BOARD ACTION REPORT – APPEALABLE ITEM

Project Name: Dunkin Donuts at Linton Square
Project Location: 1585 South Congress Avenue
Request: Class III Site Plan Modification, Landscape Plan and Architectural Elevations

Board: Site Plan Review and Appearance Board
Meeting Date: April 13, 2016

---STAFF REPORT---

DATE _____
PROJECT NO. _____
SHEET NUMBER
C-100

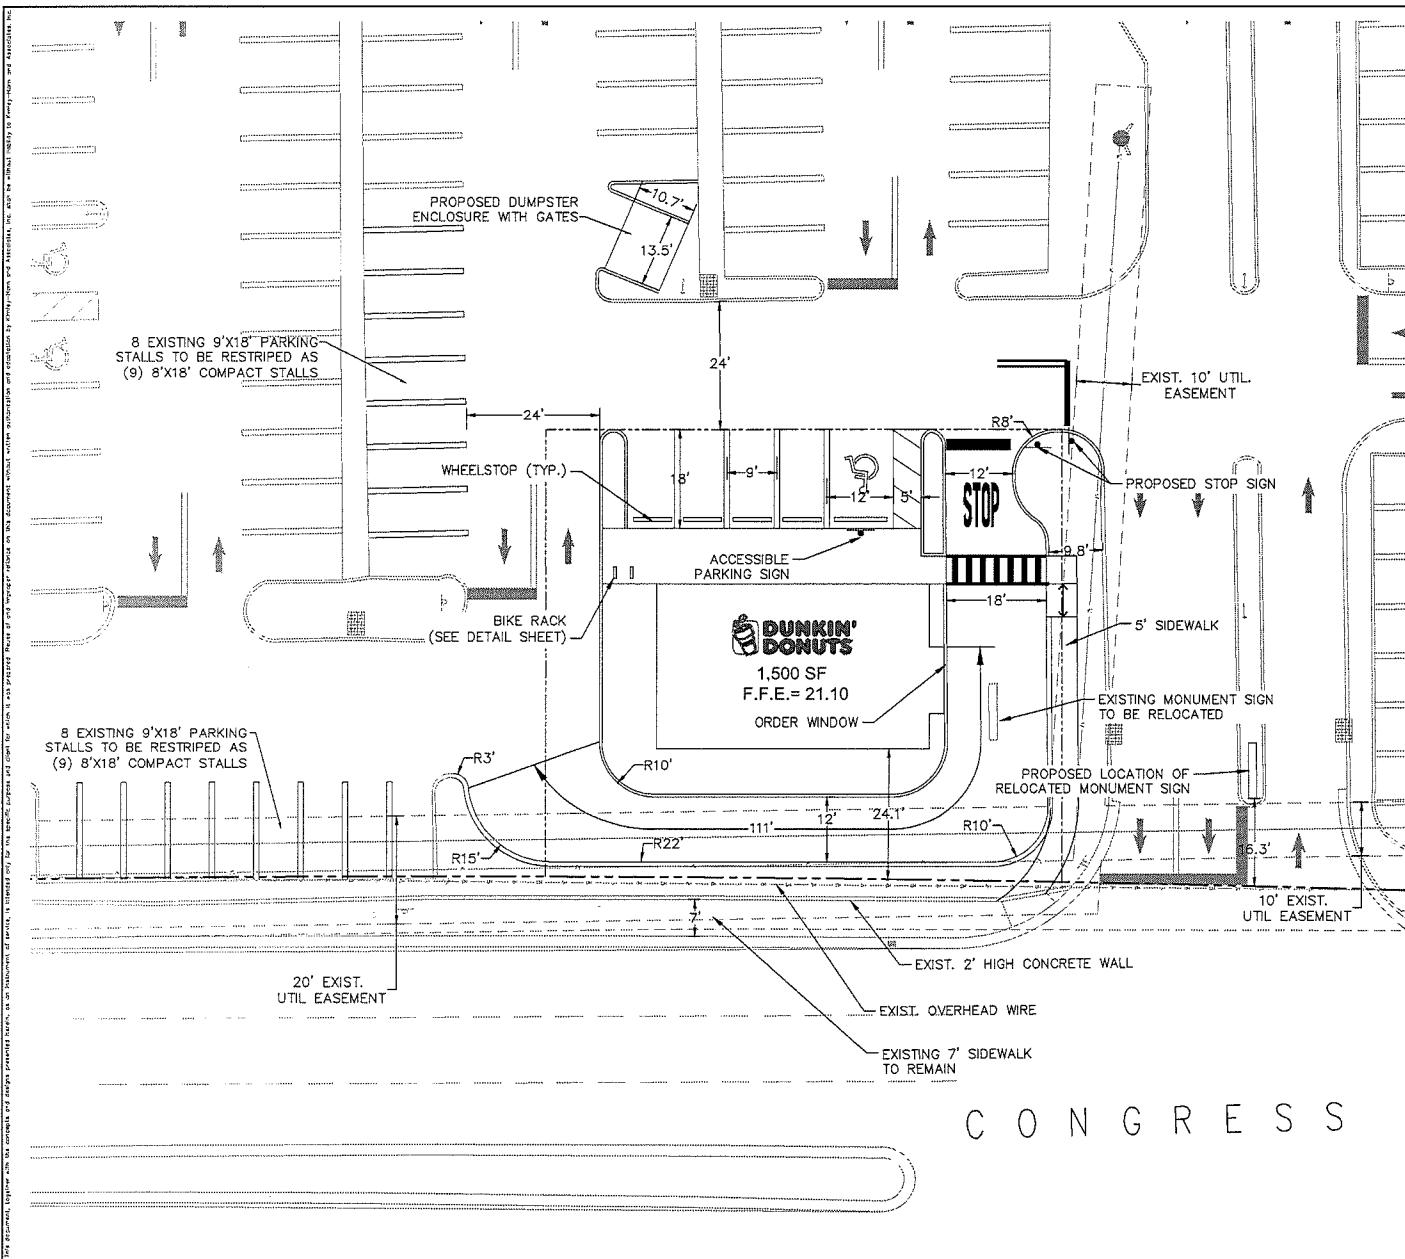
2. Correct the open space requirement on the site plan to reflect 25%, not 20%, prior to site plan certification.

4. All plans shall consistently reflect the existing or proposed location of bicycle racks. The physical location of a proposed bicycle rack is not clearly denoted on Sheets L-100, C-100, C-200 and C-300.
